Access Compliance Report

Public Rights-of-Way

(Curb Ramps)

Intersection ID: 48451	Main Street: RED_RUST_LN	Cross Street: DANCING_WIND_RD	Location: NW
ADA ID: 158222D93BD0	Ramp Type: Perp	Initial Pass/Fail: Fail	Overall Compliance: No
		Severity Score: 8.75

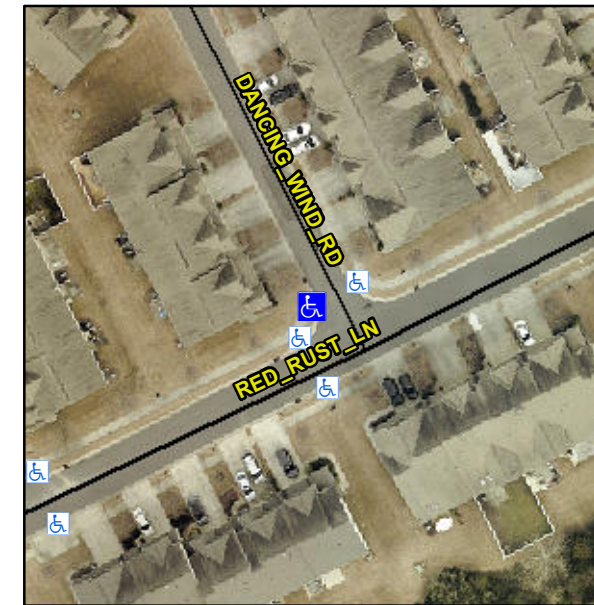
Not Found, R304.5.1

Compliance	Description	Data	Compliance	Description	Data
N/A	Ramp Length (in)	47.0	Yes	Ramp Slope (%)	5.2
No	Ramp Width (in)	47.0	Yes	Ramp XSlope (%)	0.7
N/A	Flare Type LT	N/A	N/A	Flare Type RT	N/A
N/A	Flare Slope LT (%)	N/A	N/A	Flare Slope RT (%)	N/A
N/A	Flare Traversable LT?	N/A	N/A	Flare Traversable RT?	N/A
N/A	Landing Length (in)	N/A	N/A	DWS Provided?	N/A
N/A	Landing Width (in)	N/A	N/A	DWS Contrast?	N/A
N/A	Landing Slope (%)	N/A	N/A	DWS Length (in)	N/A
N/A	Landing X Slope (%)	N/A	N/A	DWS Full Width?	N/A
N/A	Landing Curb? (Y/N)	N/A	N/A	DWS Offset (in)	N/A
N/A	Shared Landing?	N/A			
N/A	Gutter Ponding?	N/A	N/A	Gutter Slope (%)	N/A
N/A	Gutter Lip Ht (in)	N/A	N/A	Gutter X Slope (%)	N/A
N/A	Painted X Walk1?	No	N/A	Painted X Walk2?	N/A
	X Walk 1 Direction	To NE		X Walk 2 Direction	N/A
N/A	X Walk 1 Width (in)	N/A	N/A	X Walk 2 Width (in)	N/A
	X Walk 1 Slope (%)	2.2		X Walk 2 Slope (%)	N/A
	X Walk 1 X Slope (%)	0.3		X Walk 2 X Slope (%)	N/A

Remove & Replace Entire Ramp.
